September 12, 2014

RE: RESPONSE TO DISAPPROVAL
EVAPORATION POND 7 DIKE BREACH
WESTERN REFINING SOUTHWEST INC., GALLUP REFINERY
EPA ID # NMD000333211
HWB-WRG-14-003

Figure 6
FACILITIES AND WELLS
WESTERN REFINING - GALLUP REFINERY

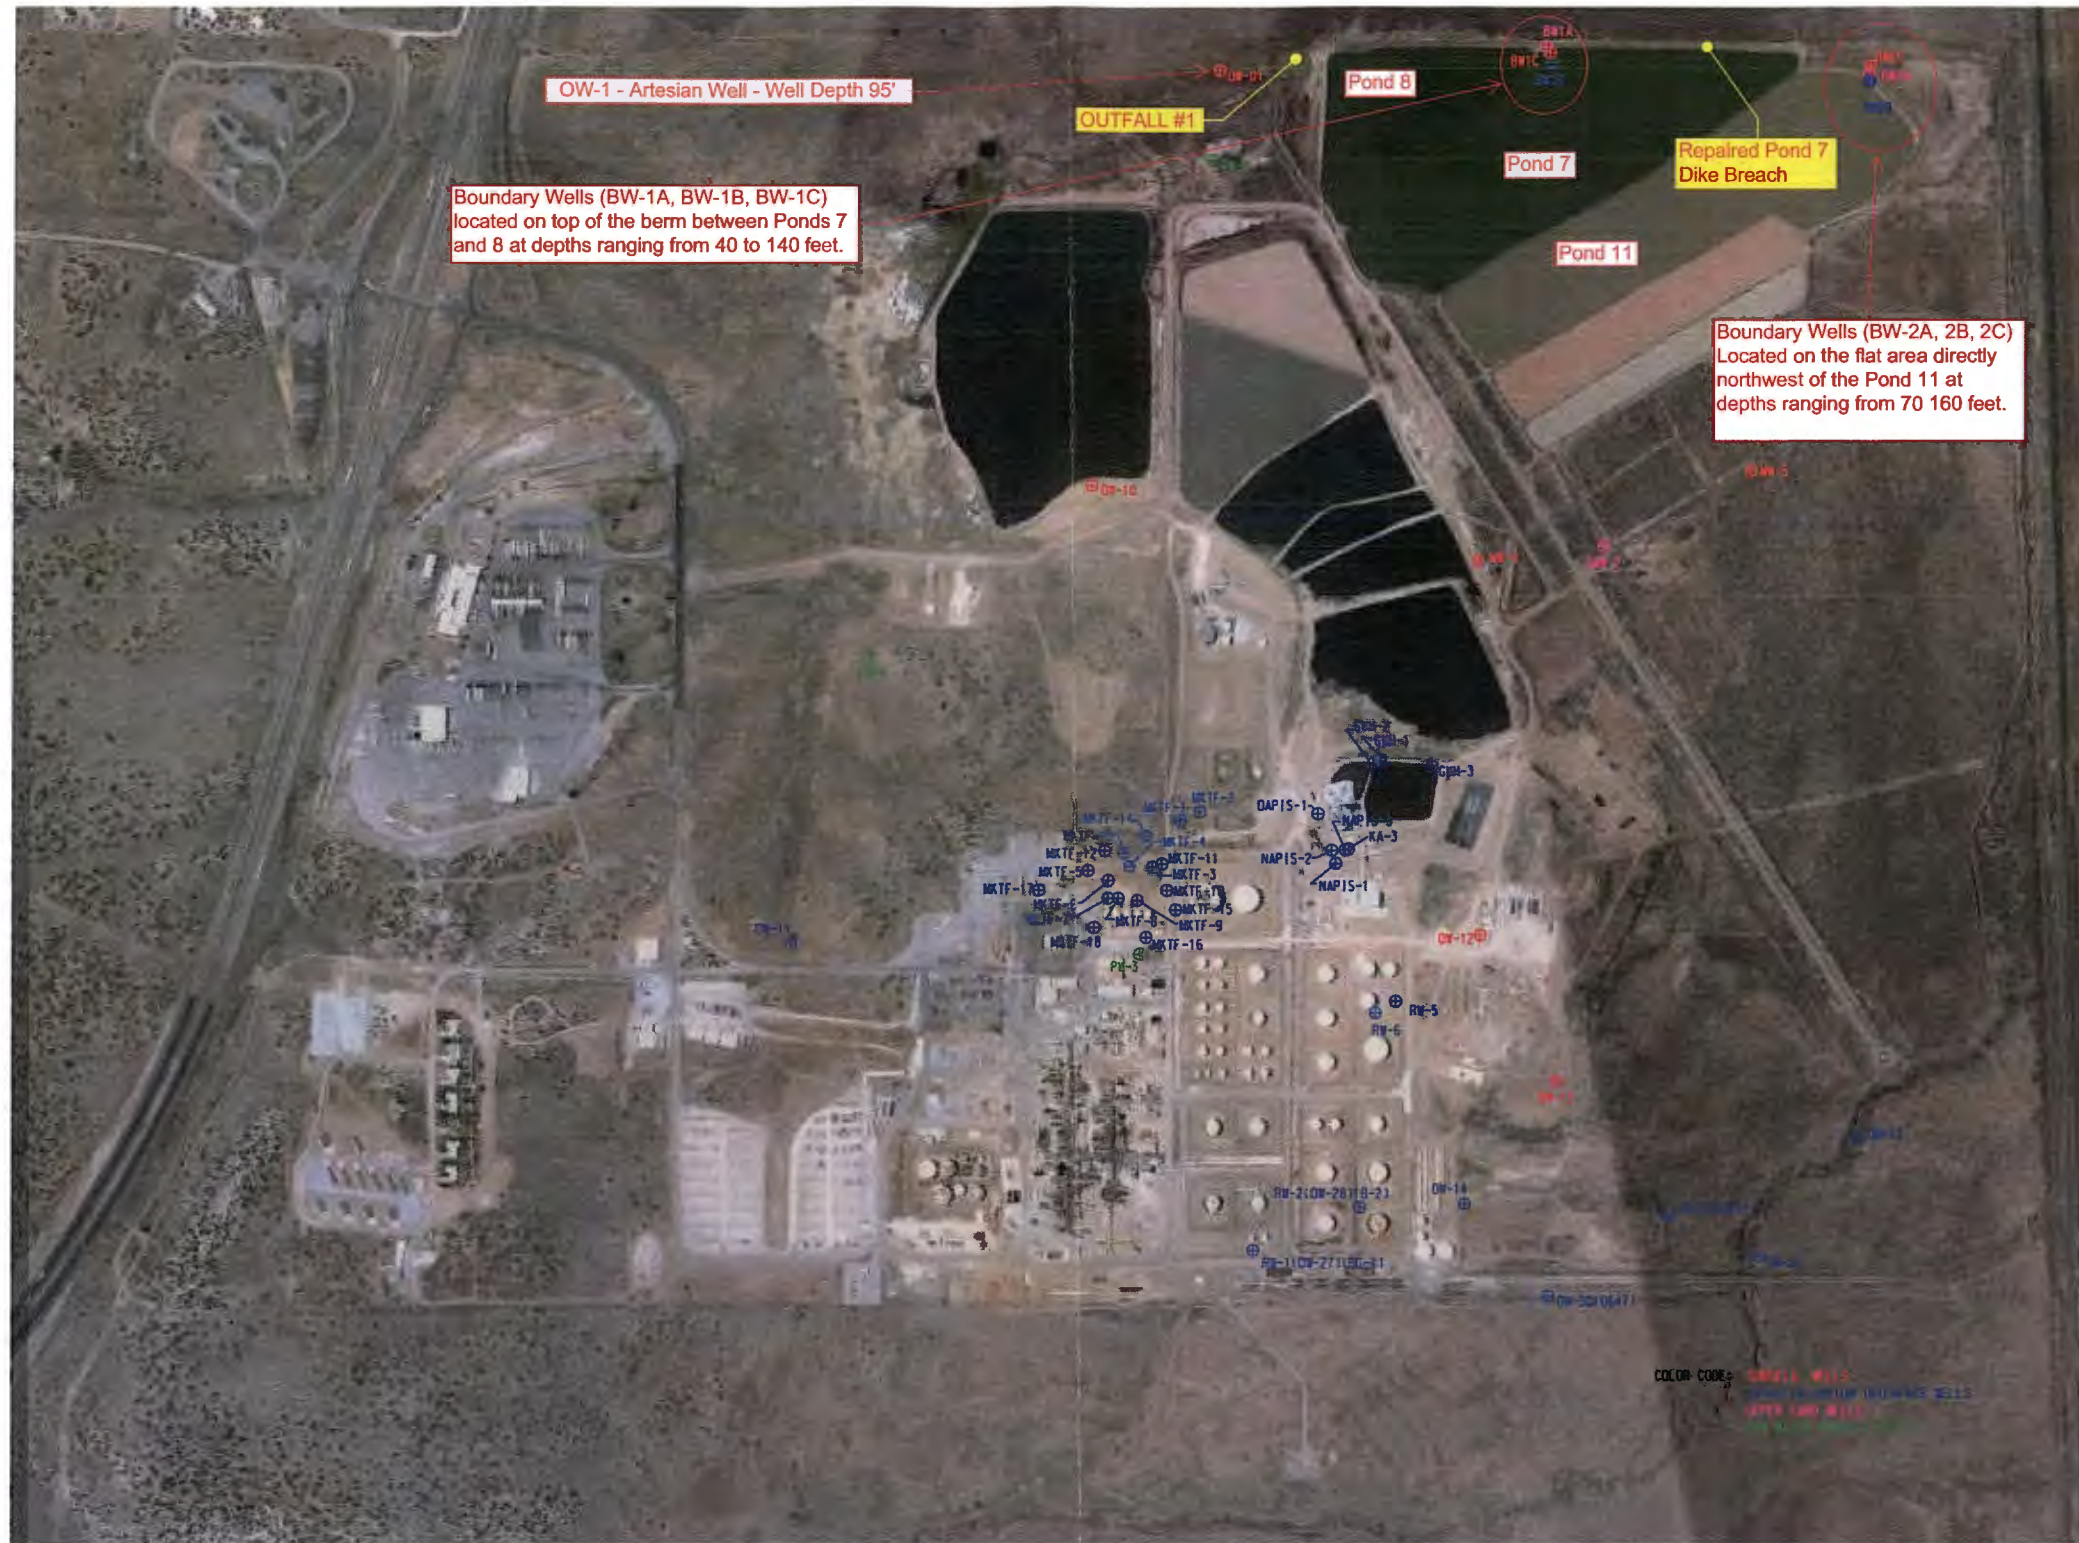
The Permittee is responsible for maintenance of the evaporation ponds. 40 CFR § 264.221(g) states that "[a] surface impoundment must be designed, constructed, maintained, and operated to prevent overtopping resulting from normal or abnormal operations; overfilling; wind and wave action; rainfall; run-on; malfunctions of level controllers, alarms, and other equipment; human error." In addition, 40 CFR § 264.221(h) states, "[a] surface impoundment must have dikes that are designed, constructed, and maintained with sufficient structural integrity to prevent massive failure of the dikes." SWMU 2 is not a permitted unit; however, the standards for surface impoundments described in 40 CFR 264 Subpart K establish the design criteria applicable to this SWMU. The Permittee failed to properly maintain the facility's structures and are subject to an enforcement action in the event of additional releases from the evaporation ponds. The Permittee must demonstrate that the dikes have been repaired and are currently maintained and must ensure that the head or freeboard maintained in the ponds is sufficient enough to maintain the structural integrity of the berms. Include information regarding the methods and materials used to repair the berms. The Permittee must note that 40 CFR § 264.227(a) requires that "[a] surface impoundment must be removed from service in accordance with paragraph (b) of this section if: (1) The level of liquids in the impoundment suddenly drops and the drop is not known to be caused by changes in the flows into or out of the impoundment; or (2) The dike leaks." In the future, if additional berm failures occur, the Permittee will be subject to the requirements outlined in 40 CFR § 264.227(a) through (e). Provide a contingency plan and an inspection plan for berm

maintenance. Provide a figure depicting the location of Outfall 1 and the groundwater monitoring wells in the vicinity of the breach.

This work was completed in May 2014 at a cost of \$425,000. With respect to the dike improvements, and Pond 7 dike repair work, included in these activities, ninety five percent of the material used for the pond repairs was virgin soil dug from two locations on refinery property. The other five percent was primarily rip-rap material consisting of construction demolition material such as concrete. The soil was taken to the ponds with dump trucks. The unloaded soil was then moved with a front loader or in tight areas an excavator and a dozer was used to compact and contour the soil. The pond berms were widened and where room allowed the side walls were contoured to improve the outside slope of berms. Attached for your information is a figure depicting the location of Outfall 1 and the monitoring wells in the vicinity of the now-repaired Pond 7 dike breach.
